FIELD ORDER LOG AND FIELD ORDERS

Camp Georgetown Remediation Site

Camp Georgetown Remediation Site
 NYSDEC Site No. 7-27-010
 Contract No. D006614
 Contractor: OP-TECH Environmental Services Corp

CAMP GEORGETOWN
NYSDEC SITE # 7-27-010
CONFIRMATION SAMPLING LOCATIONS
Gas House - Test Pit #14

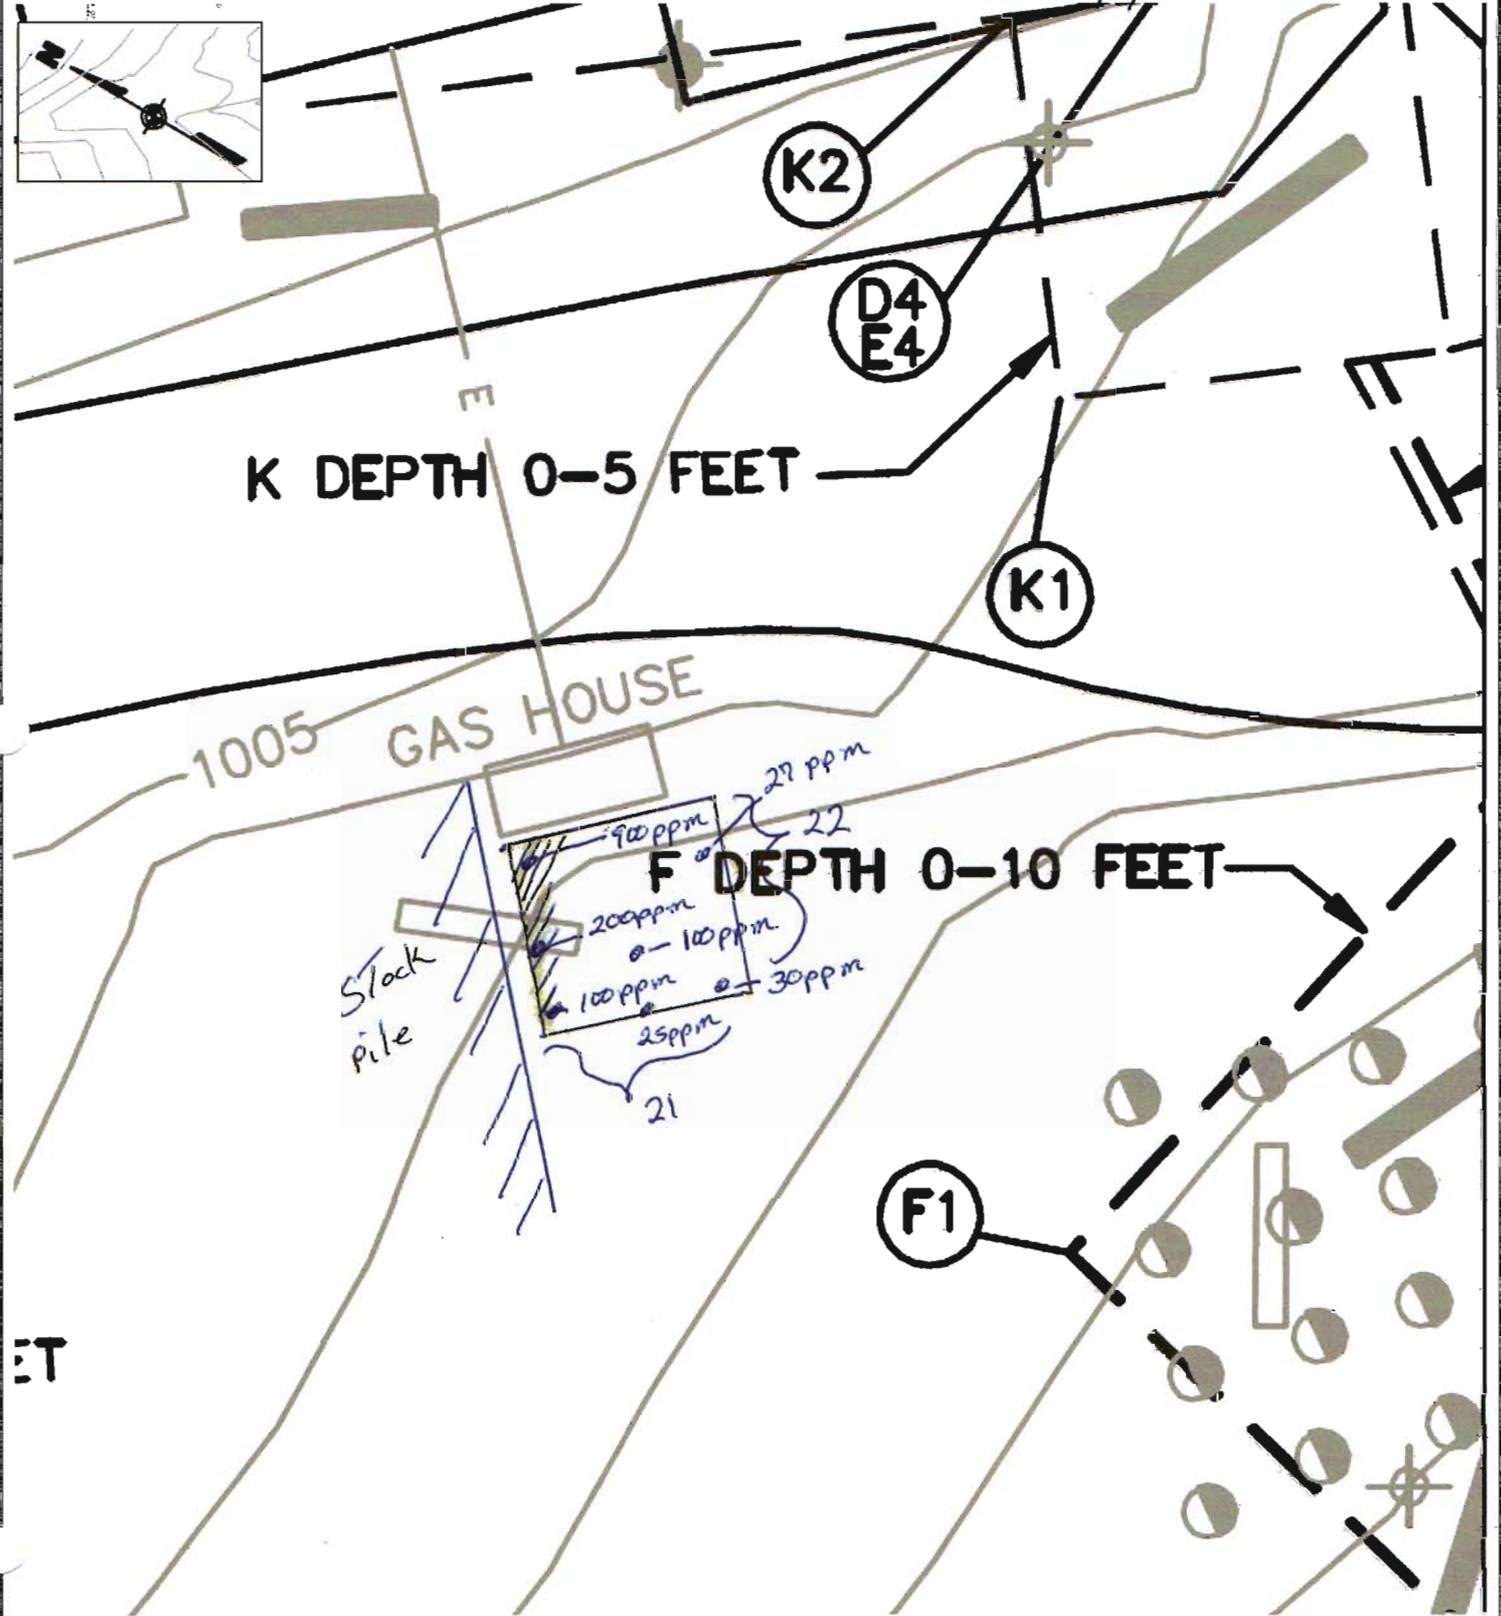
1. **Gas House area – Test Pit #14:** excavate 20' x 20' area centered on test pit #14, as directed in the field, to a depth 1' below the former tank installation depth which has been estimated at 8' deep, however only excavate up to the gas house building. Then using a PID meter scan the remaining soils and if still hot URS/Department will re-evaluate building demo. (Note: 20' x 20' is based on ½ the distance between 2 clean test pits)
The 20' x 20' area was excavated on 9/4 & 9/5 and the PID readings on the NW wall are 100 to 900 and considered high. The contractor shall excavate the NW wall and scan with the PID until the results are similar to the other wall readings and then collect confirmation samples per specification requirements for STARS - VOC's and SVOC's. (See attached Map)

2. **Test Pit #6 – hot for PCP:** excavate 12' x 12' area centered on the test pit to a depth 1' below the test pit excavation, which was 10'.
Collect confirmation samples per specification requirements.

3. **AOC-J:** collect confirmation samples per specification requirements.

CAMP GEORGETOWN
NYSDEC SITE # 7-27-010
CONFIRMATION SAMPLING LOCATIONS
AOC-C
Field Order #14

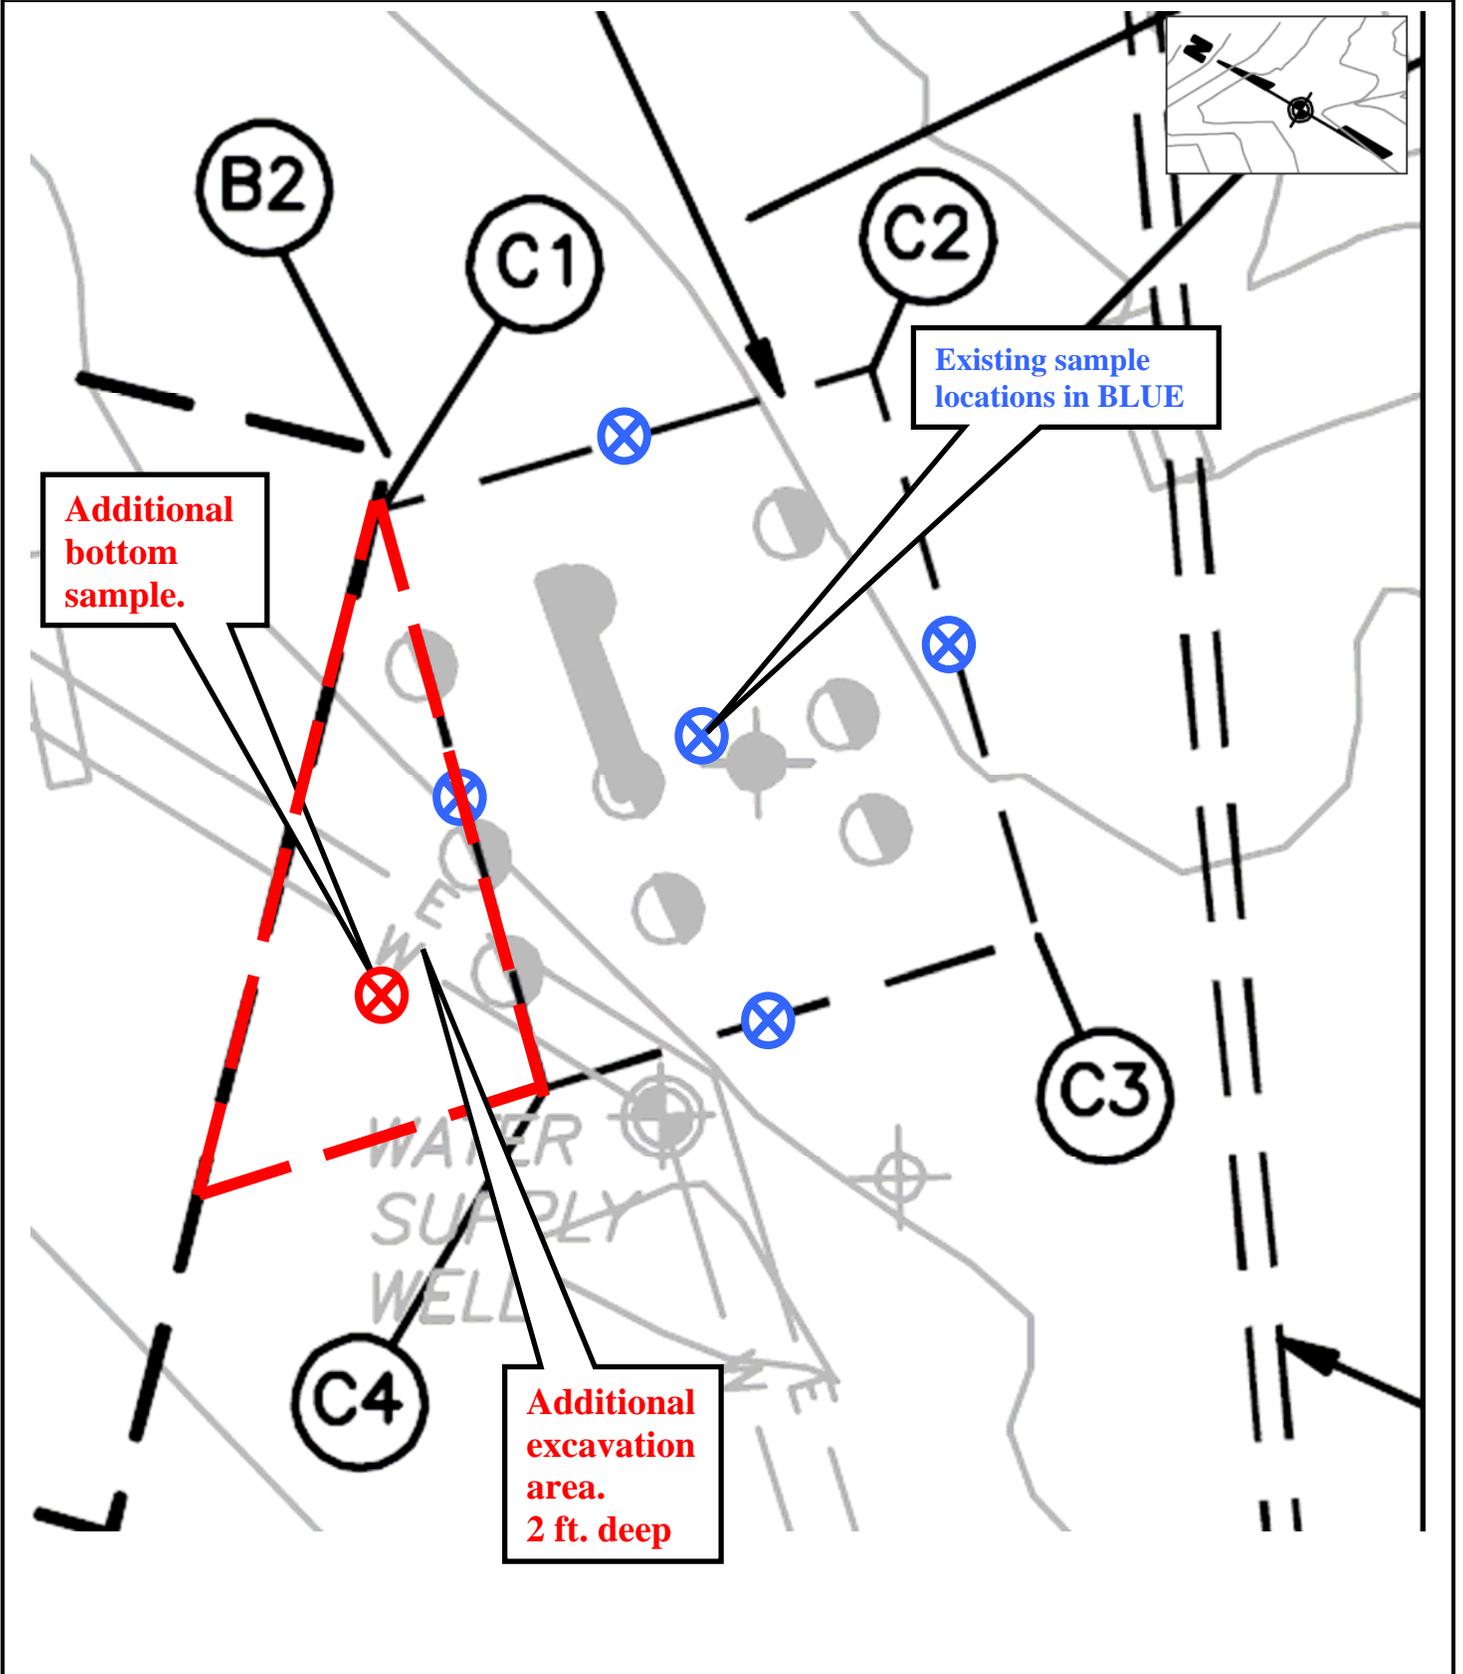
1. Contractor shall excavate, transport and dispose of the following soil: (see attached map)

Soil represented by Sample ID	Depth (thickness) of Additional Excavation (ft.)	Required Post-Excavation Analyses
AOC-C North Wall	Excavate to AOC-B	None -North wall eliminated
AOC-C Bottom	New Bottom – 2 ft.	1 sample - Complete Analyses
AOC-C West Wall	New West Wall – 25 lf.	None – less than 30 feet

CAMP GEORGETOWN
NYSDEC SITE # 7-27-010
CONFIRMATION SAMPLING LOCATIONS
AOC-C
Field Order #14

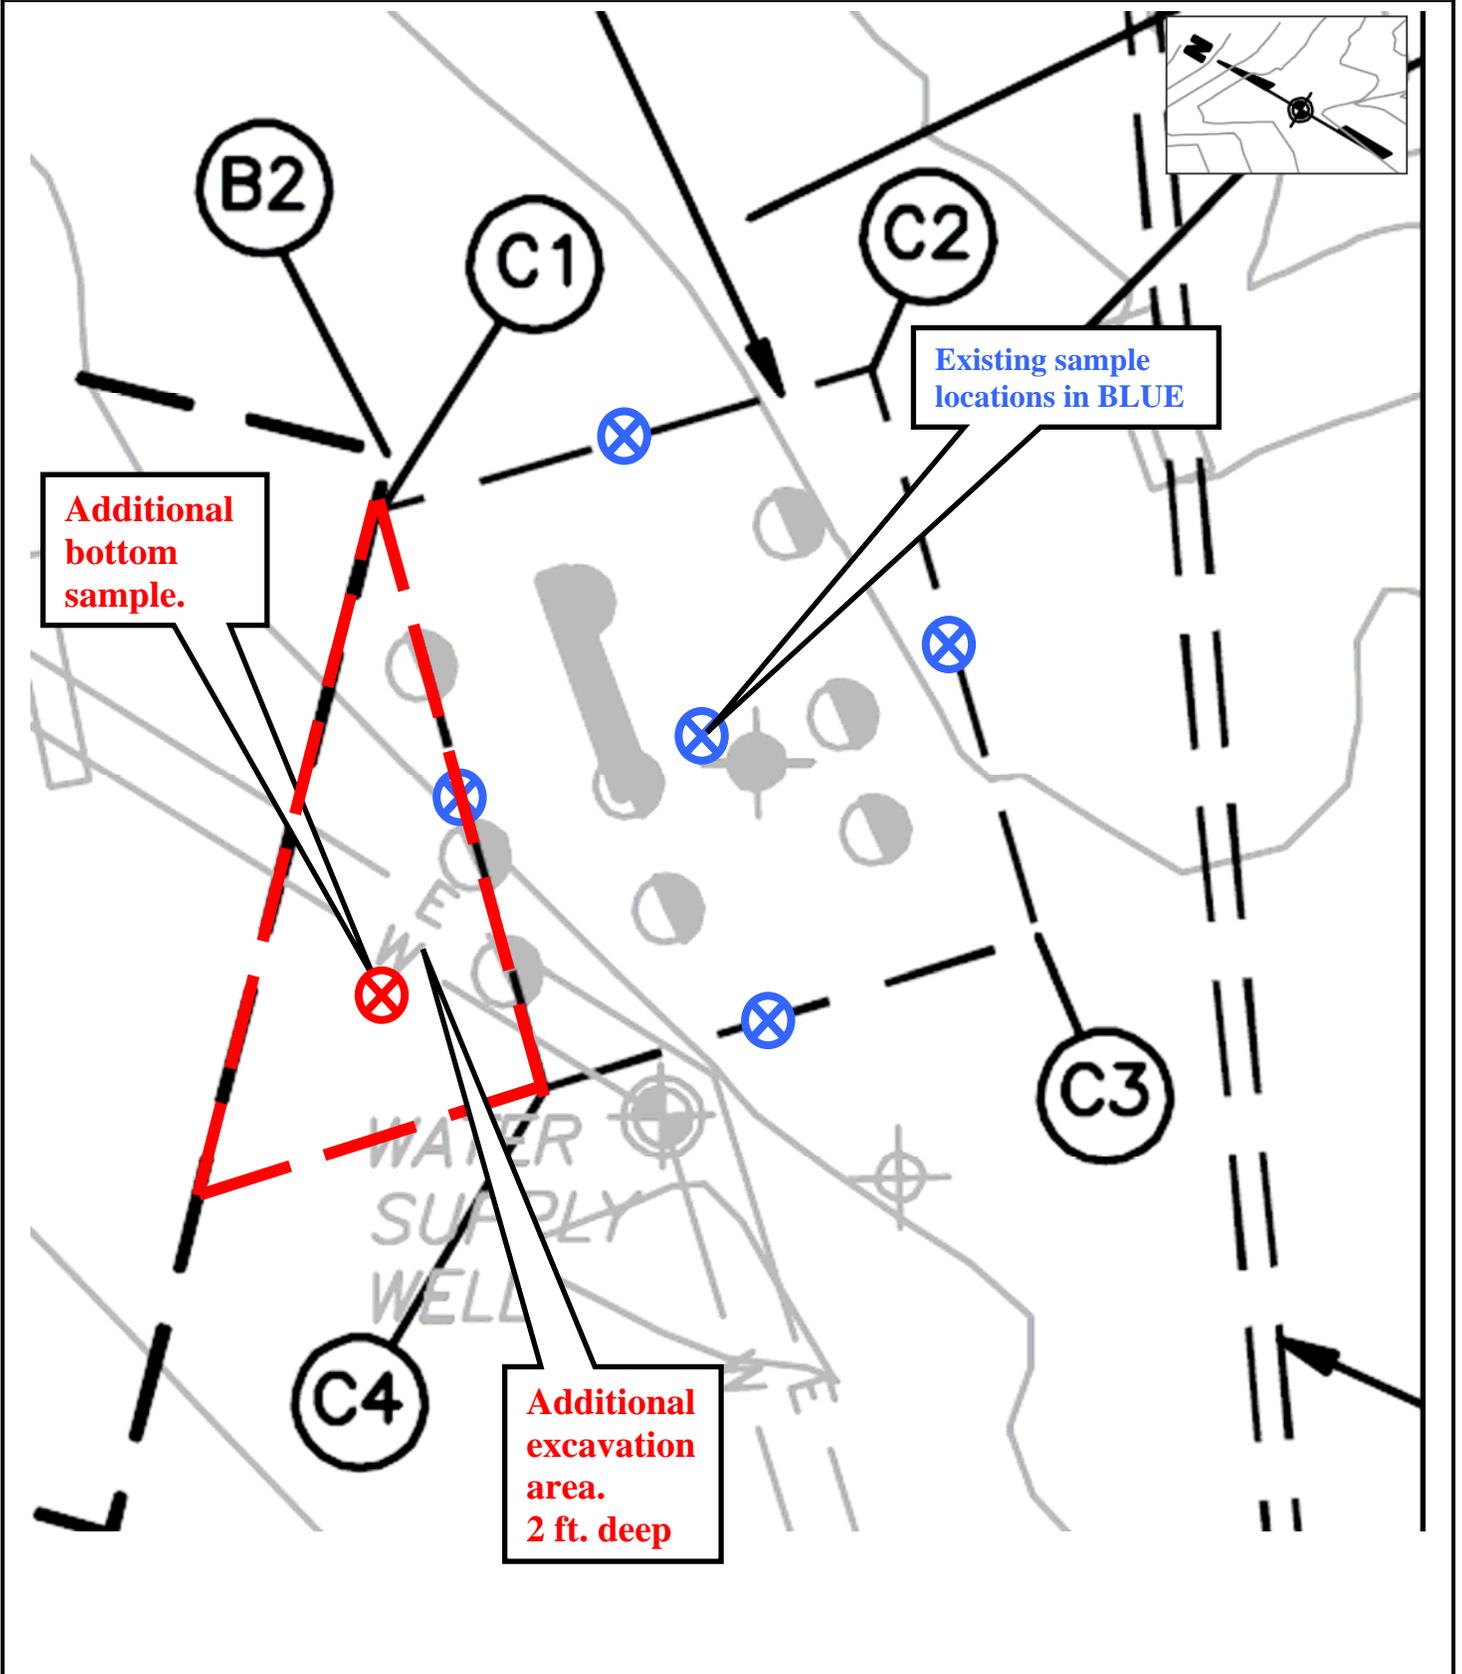
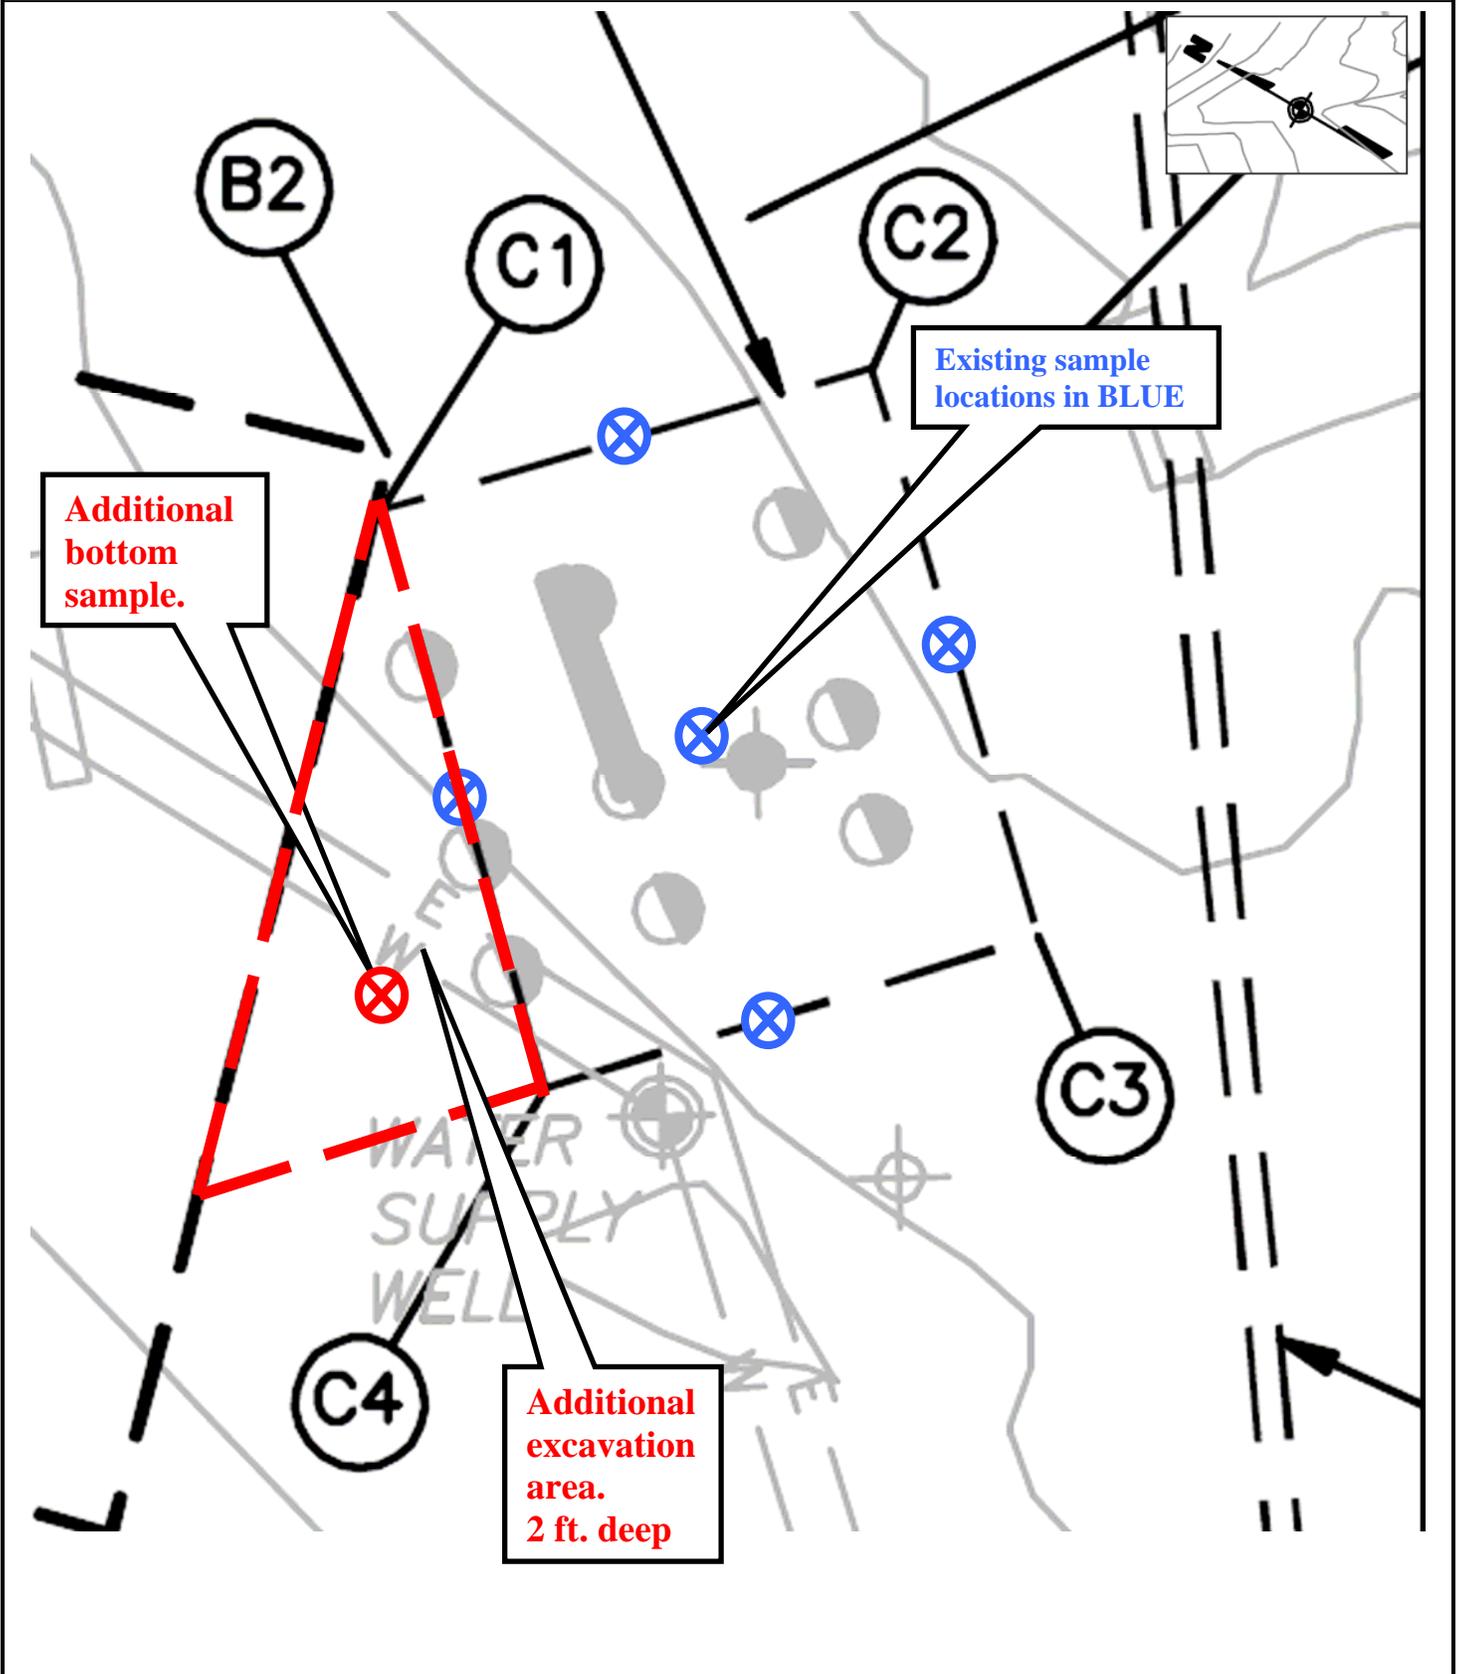
1. Contractor shall excavate, transport and dispose of the following soil: (see attached map)

Soil represented by Sample ID	Depth (thickness) of Additional Excavation (ft.)	Required Post-Excavation Analyses
AOC-C North Wall	Excavate to AOC-B	None -North wall eliminated
AOC-C Bottom	New Bottom – 2 ft.	1 sample - Complete Analyses
AOC-C West Wall	New West Wall – 25 lf.	None – less than 30 feet
